**PLANNING, ZONING, & BUILDING DEPARTMENT**  
**PZ&B Staff Combination Memorandum: Architectural Commission and Town Council**

**SUBJECT:** ARC-23-137 (ZON-23-104) 310 CLARKE AVE

**MEETING:** NOVEMBER 20, 2023 ARCOM  
DECEMBER 13, 2023 TC

Rear Loggia

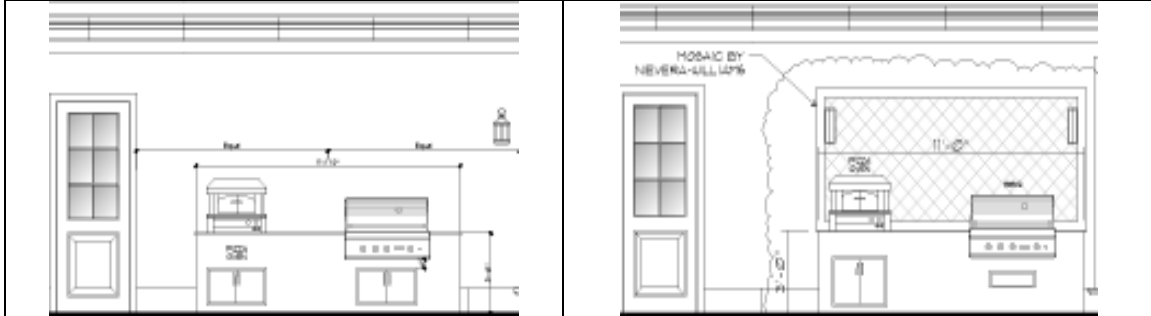
Architectural changes to the structure are relatively minor and include changes in railing design at front and rear balconies, change in loggia columns, elimination of shutters on the east and west elevations at the garage/kitchen wing, a and slight modification to the outdoor kitchen area including addition of an installed tile mosaic on the south façade. Changes of this level can often be reviewed and approved at the staff level with consent of the Chairman, however, due to the other outstanding issues requiring variances, the entirety of the application was required to return to the commission, rather than bifurcating approvals.

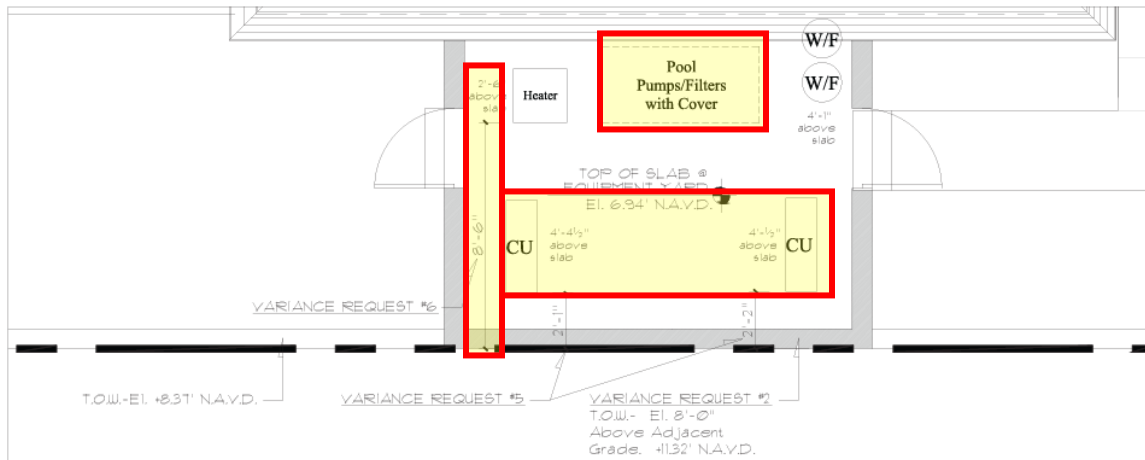
The violations related to this application were listed previously and are depicted graphically below:

*Variances for A/C equipment closer than 5' to property line, and 3 pieces of A/C equipment in setback.*

Eastern Equipment Yard Plan Diagram

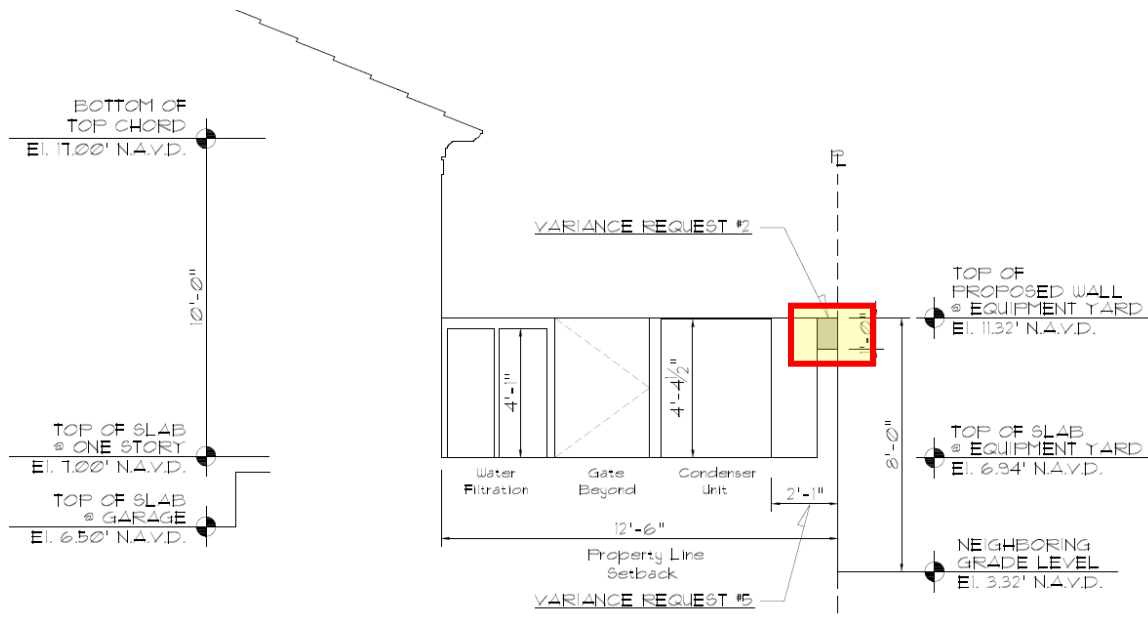
Variance for pool heater less than 10' to property line. Variance for A/C equipment less than 5' to property line. Variance for pool pumps/filters unhoused.

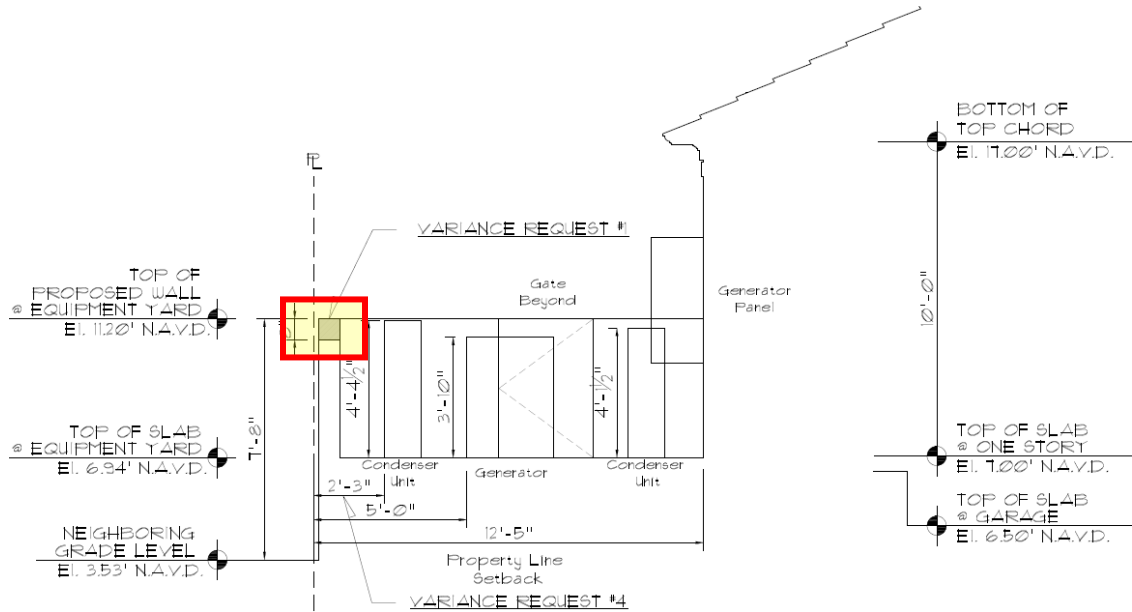
Variance for equipment wall to exceed max. 7' height above lowest grade.

Variance for equipment wall to exceed max. 7' height above lowest grade.
